6.0 Responses to Comments

Re: Draft Mitigated Negative Declaration and Initial Study for the Palermo-East Nicolaus
115-kV Transmission Line

PALERMO - EAST NICOLAUS 115-KV TRANSMISSION LINE
PG&E COMMENTS ON THE DRAFT MITIGATED NEGATIVE DECLARATION
AND INITIAL STUDY

B1 James Hill

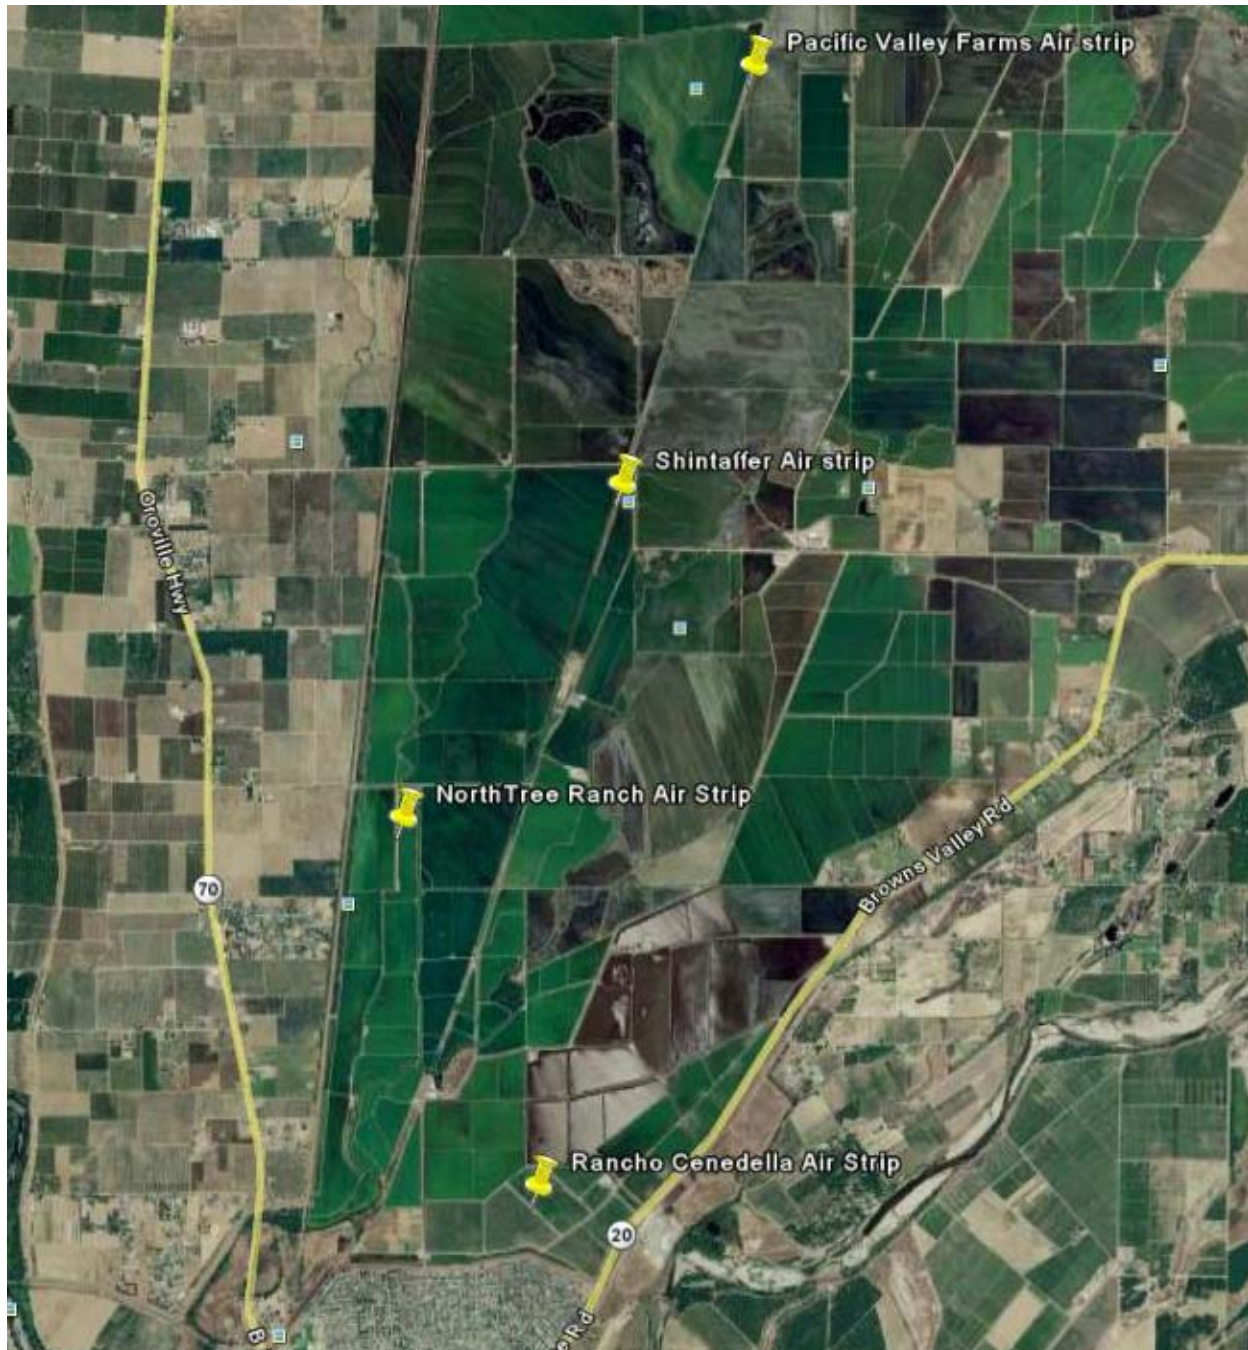
The same commenter also stated that some of the airstrips near the project route were not documented in the MND/IS. After the meeting, the commenter sent a message to the project email address with an attachment showing the location of four private agricultural airstrips north of Marysville, CA and east of State Route 70: Pacific Valley Farms Airstrip, Shintaffer Airstrip, NorthTree Ranch Airstrip, and Rancho Cenedella Airstrip (Section 6.2, Responses to Comments from Individuals Received During the Public Review Period, B1 James Hill).

As promised here are the air strips located on Google Earth and that image provide you with lat and long for all 4 of the airstrips in your project area. Please confirm with a return e mail that you have received this map and the information you requested.

Although each of the airstrips appear to be within 2 miles of the proposed project route, the impact determination for checklist item "f" in Section 3.8, Hazards and Hazardous Materials, would remain unchanged. The analysis for item "f" uses Siller Bros Inc. Aviation's private airstrip, which is also located within 2 miles of the project route, as a basis for analysis. Under checklist item "e," it is determined that

since the poles to be installed for the proposed project would not be greater than 120-feet tall, no obstruction to navigable airspace would occur. See also the analysis for checklist item “c” in Section 3.16, Transportation/Traffic.

The FAA requires notice about construction or alteration projects that exceed a height restriction of 200 feet above ground level per Federal Aviation Regulations (FAR) Part 77. Since the existing steel towers range in height from 75 to 95 feet and the replacement structures would range in height from 80 to 120 feet, the project would not constitute a new obstruction to navigable air space under FAR Part 77. Local ordinances and general plans, including the Yuba County Airport Comprehensive Land Use Plan (SACOG 1994), were reviewed for policies and ordinances associated with crop dusting, but none would apply to the proposed project. The owners or operators of each of the four private agricultural airstrips north of Marysville, California and east of State Route 70 that were listed in the email from Commenter B1, James Hill, have been added to the mailing list for the proposed project.

All comments received during the public review period for the Draft MND/IS are included in the public record and will be taken into account by decision-makers when they consider the proposed project. In addition, refer to the discussion about airstrips in Section 6.1, Public Meeting Comments Summary and Responses.
